BURGESS GYMNASIUM AND GYMNASTICS CENTER RESPONSE TO COMMENTS DOCUMENT

STATE CLEARINGHOUSE NO. 2008112082

June 2009

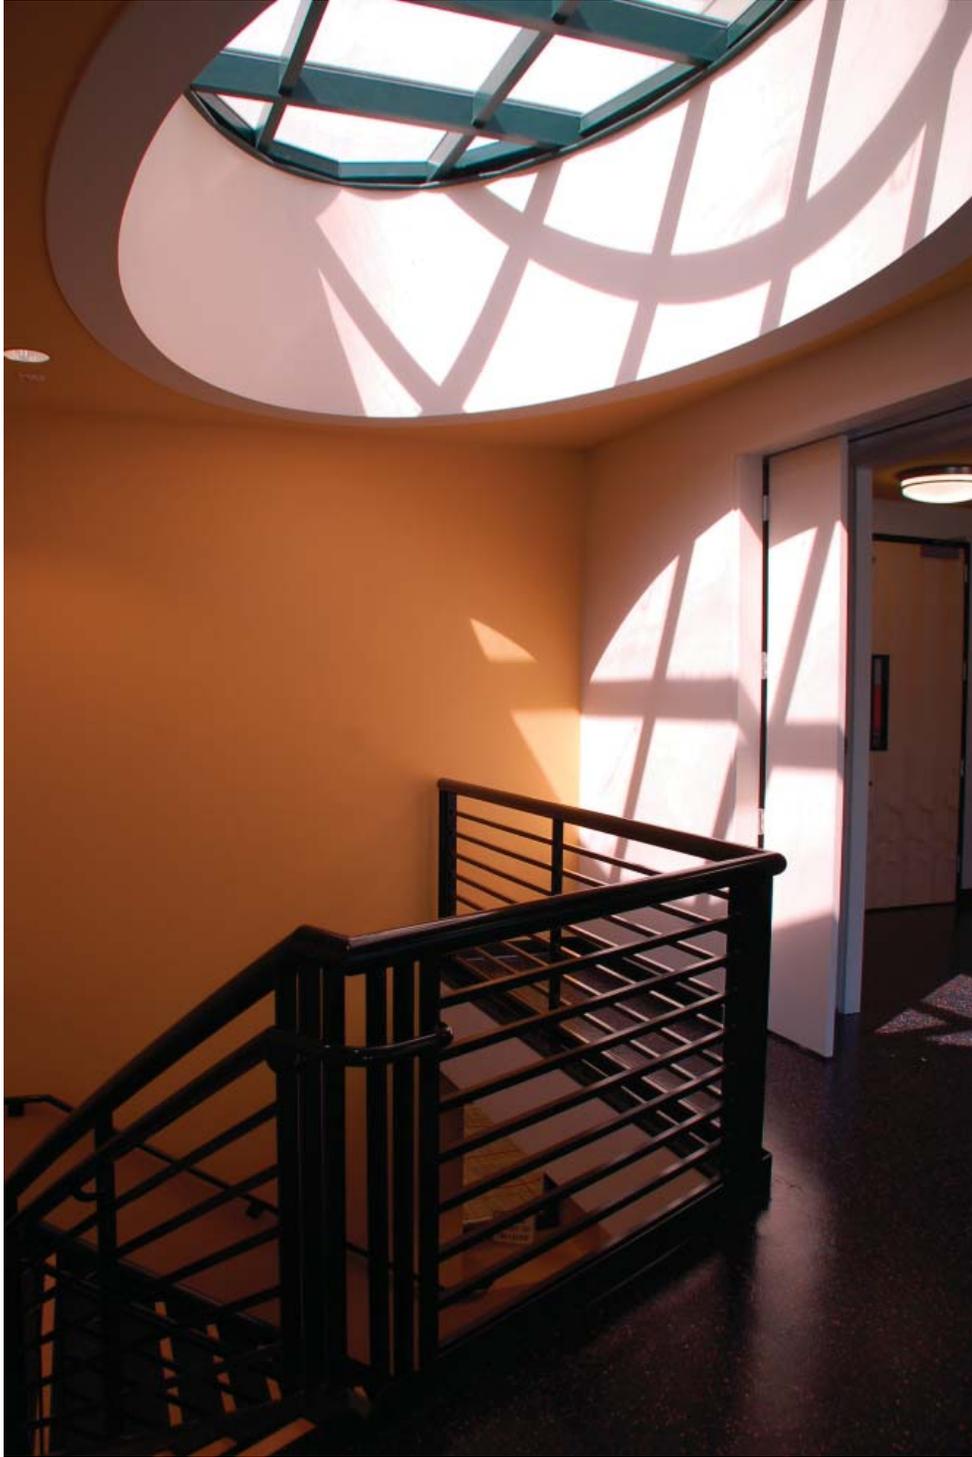
My concern is that the proposed buildings are not up to an aesthetic standard that Menlo Park should expect. To be frank, they are boring. These buildings should look forward, not backward in time. They should enhance their site, not strive to blend in. They should be inviting and exciting. They should not be brick. They should have color. They should invite people in.

Please insist that the architects redesign, and if they can't do it, then hire someone else. Please see the attached photos of the gym at Castilleja High School, designed by Kornberg Associates, permitted under drawings by Hoover Associates and John Arrillaga, built by Vance Brown Builders.

FIGURE IV-2

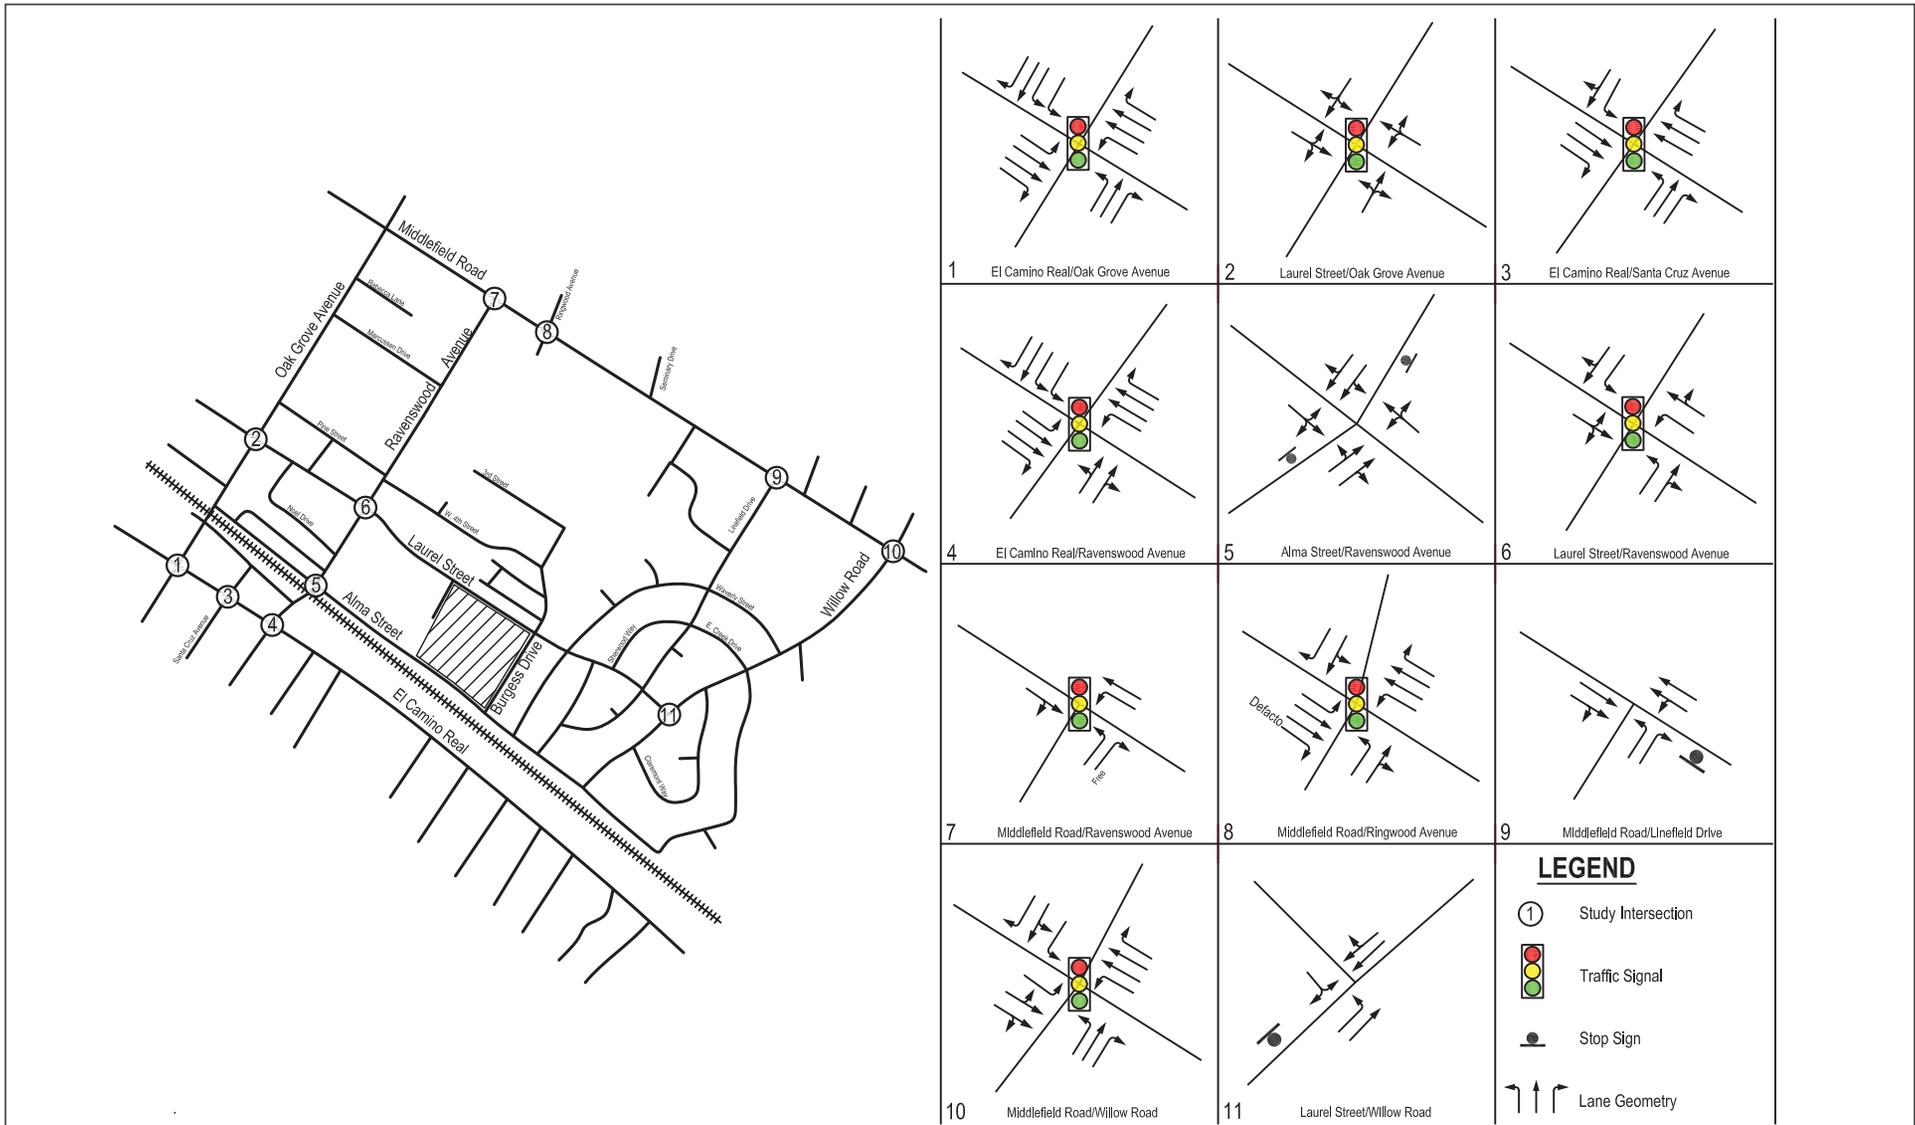
2. City Staff at the 5/4/2009 Planning Commission meeting admits the DEIR contains lane geometry errors in Figure 4.2 and other similar figures which would lead both Planning Commissioners and any readers to incorrect conclusions. Staff goes on to say it is a minor error, but how would the public know this? Additionally, it was not revealed by Staff until queried by the Planning Commission. It should have been corrected before the DEIR was released, given the importance and impact of the project.

Response C1-2: An error did exist in the geometrics at the intersection of Alma Street and Ravenswood Avenue and has been corrected. Figure IV-2, page 37 of the Draft EIR has been revised (see attached Figure IV-2, Existing Lane Geometrics and Traffic Controls [Revised]).

Figure IV-2 on page 37 of the Draft EIR is modified as follows:
